PRODUCT CHANGE NOTICE

Package Outline Drawing Update for Intersil PBGA Packaged Products

**Refer to:
PCN10112**

Date: November 5, 2010

New POD – PCN10112

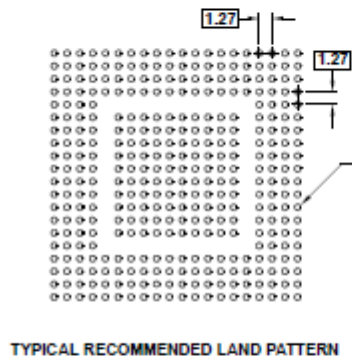
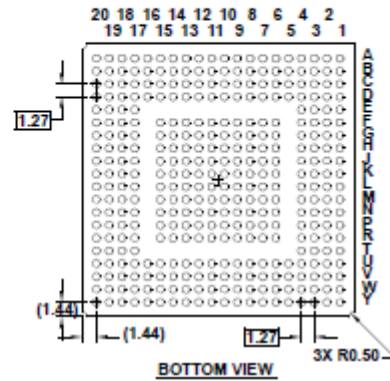
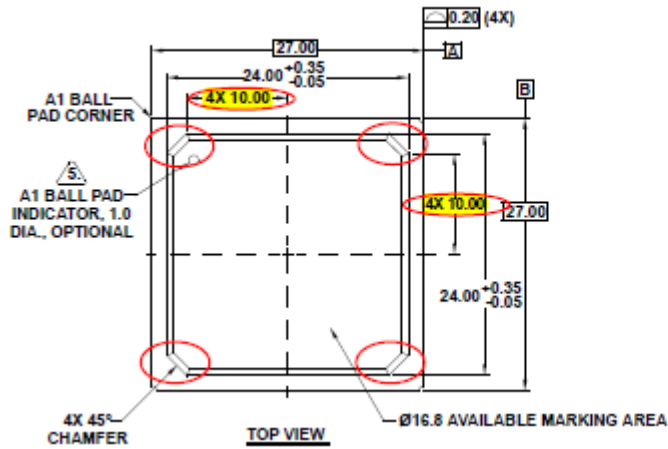
This notice is to inform you that Intersil has updated the POD (Package Outline Drawing) for the listed PBGA (Plastic Ball Grid Array) packaged products. The POD updates are the result of an upgrade in the tooling used in the assembly operations and affect the corner chamfer dimensions of the lid and the thickness of the package base/body. The current and new PODs with the changes identified are included for reference. Both the current and new PODs conform to JEDEC outline MS-034/A variation BAL-2. Revisions to the data sheet specifications incorporating the POD updates are in progress and will be available on the Intersil web site upon release.
